Reference: 48-Hour Letter - Additional Exhibits
DCI2021-00014 – Williams Avenue CPD

REVISIONS FOR HEX HEARING JUNE 28, 2022

Williams Avenue CPD
Proposed Schedule of Uses
Revised 6/23/2022

**Williams Avenue CPD
Schedule of Deviations
Revised 6-23-2022**

PROPERTY DEVELOPMENT REGULATIONS MCP A

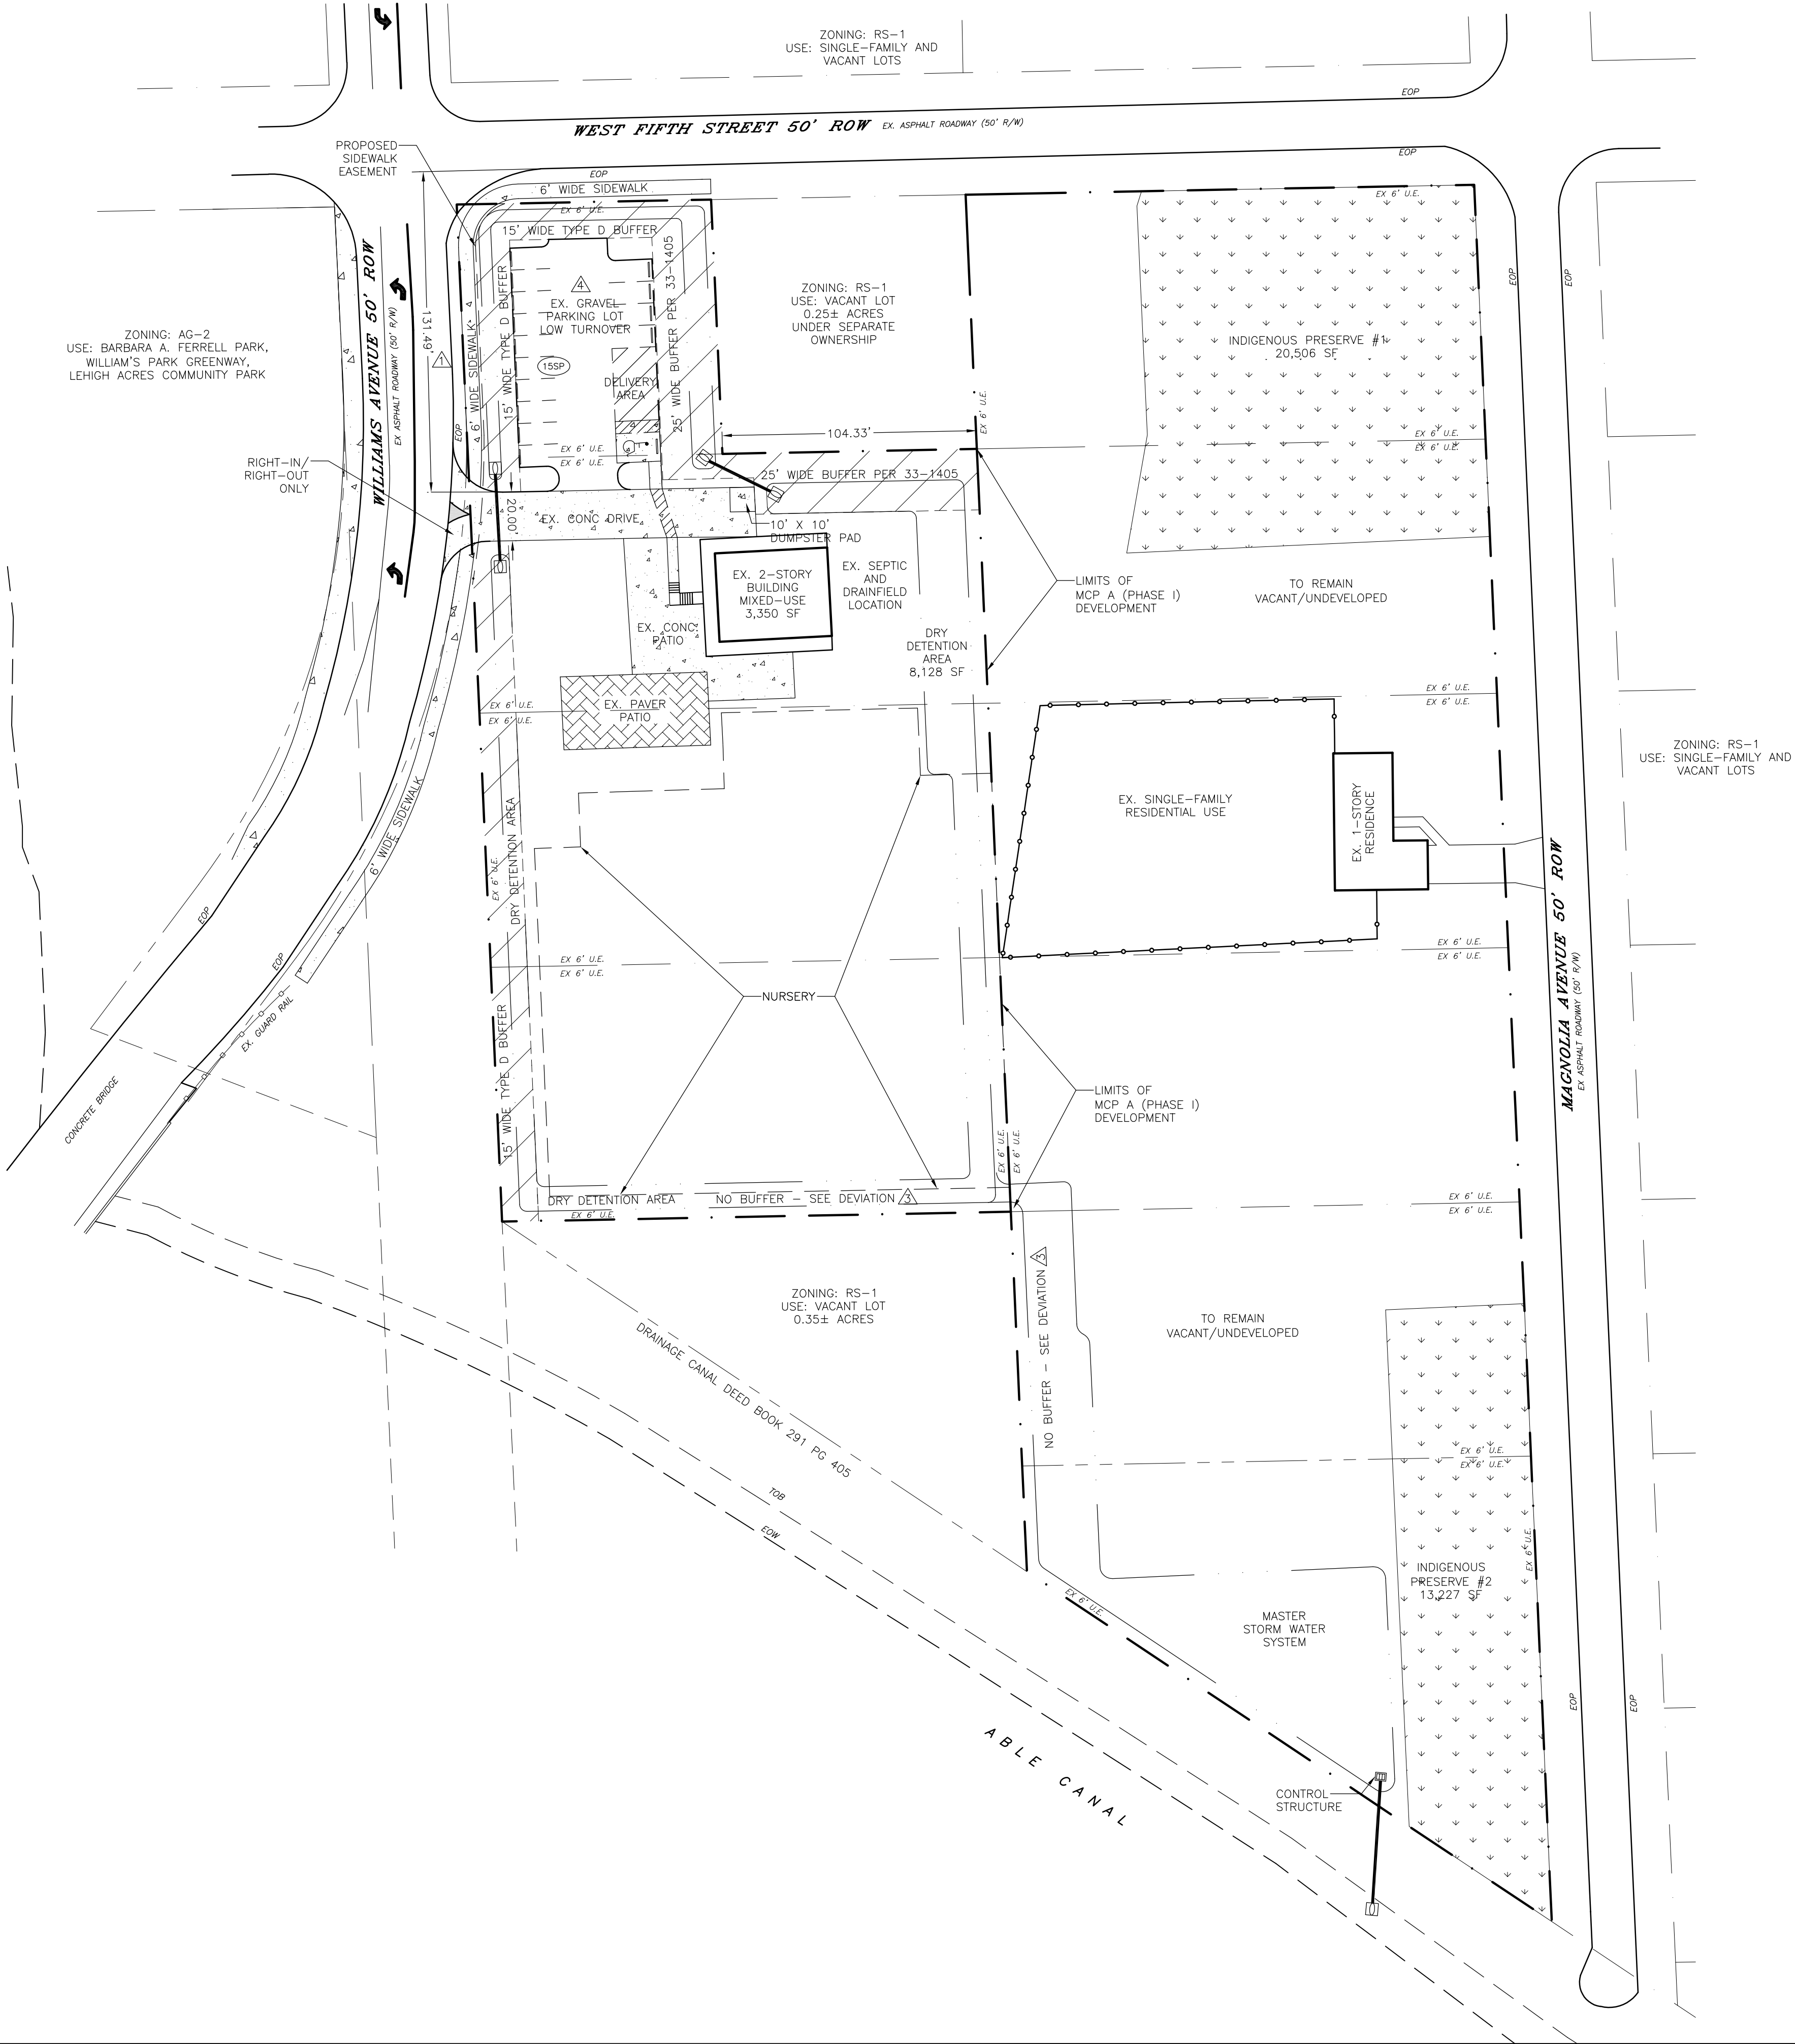
MCP A OPTION 1:

Master Concept Plan A

- Amended MCP to show a right-in/right-out only driveway on Williams Avenue;
- Removed the food truck location and drive aisle; and
- Removed extraneous text from MCP

MASTER CONCEPT PLAN B

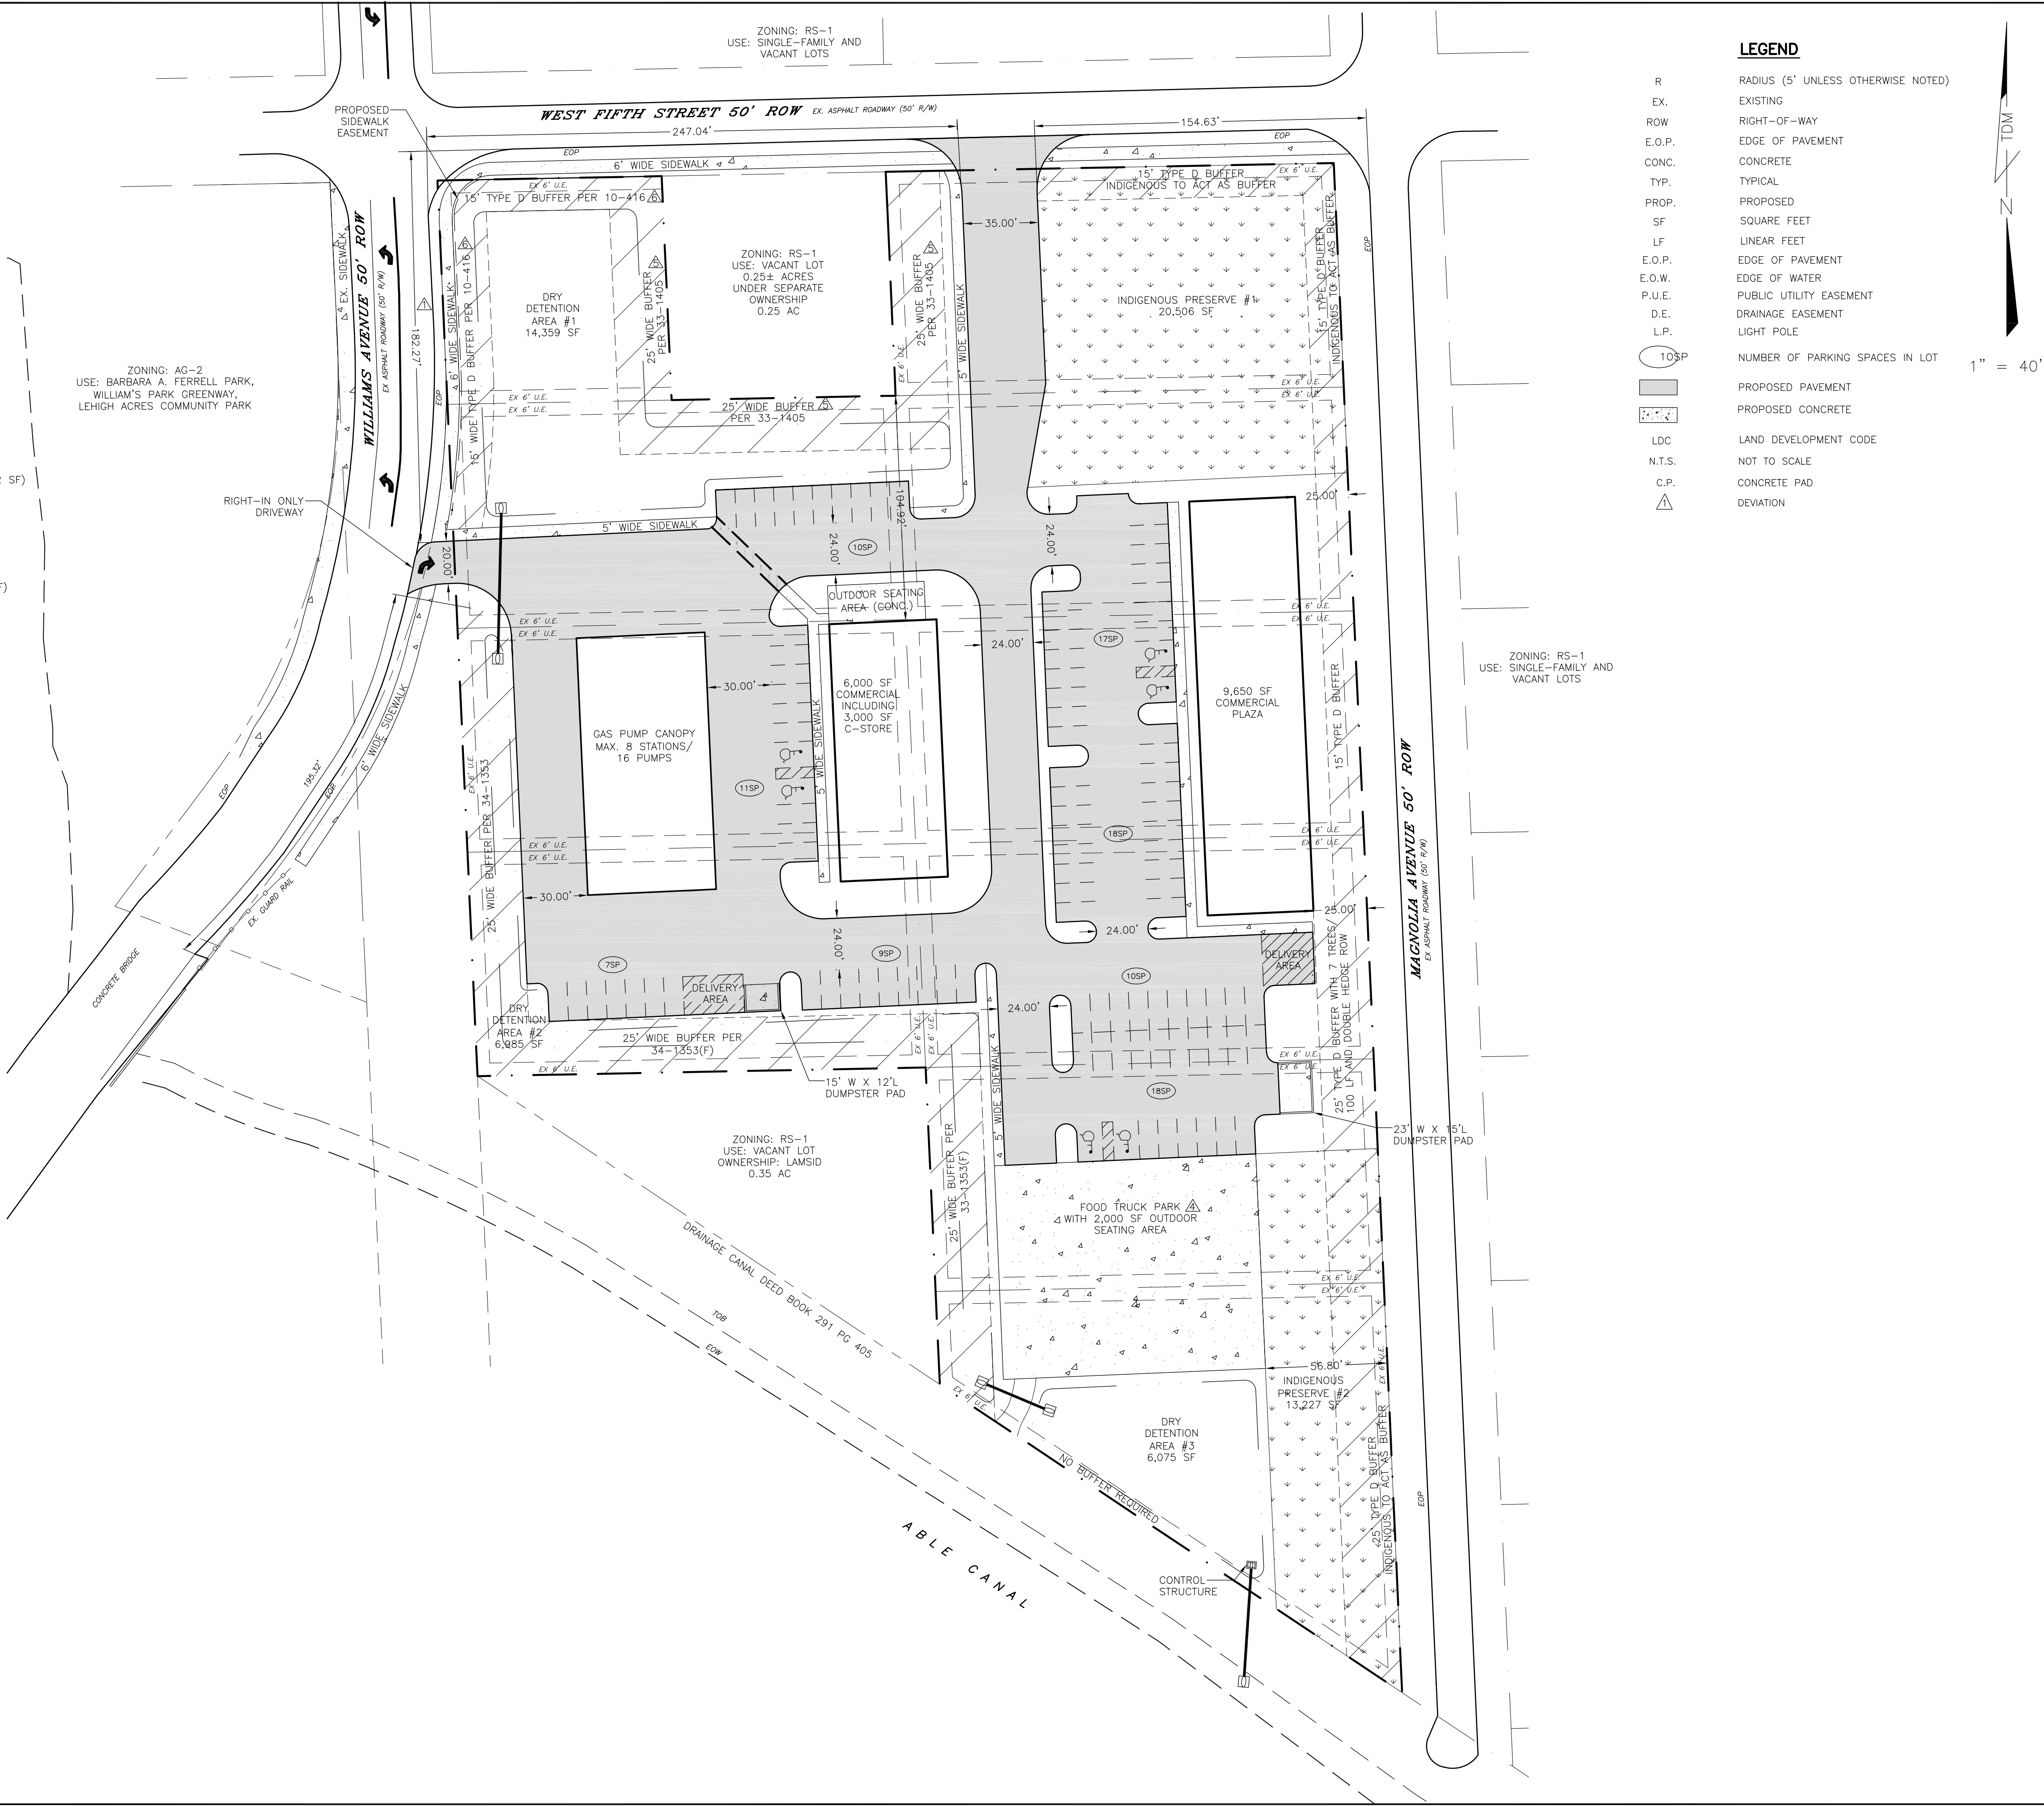
Master Concept Plan B

- Reduced intensity from a maximum of 30,000 sf to a maximum of 20,000 square feet;
- Amended MCP B to show a right-in only driveway on Williams Avenue;
- Removed proposed drive-thru lane; and
- Enhanced the ROW buffer between the food truck park and Magnolia Avenue from a 15-foot wide Type D buffer with 5 trees per 100 lf and double staggered hedge row to a 25-foot wide Type D buffer with 7 trees per 100 lf and double staggered hedge row (indigenous preserve to act as buffer where possible)
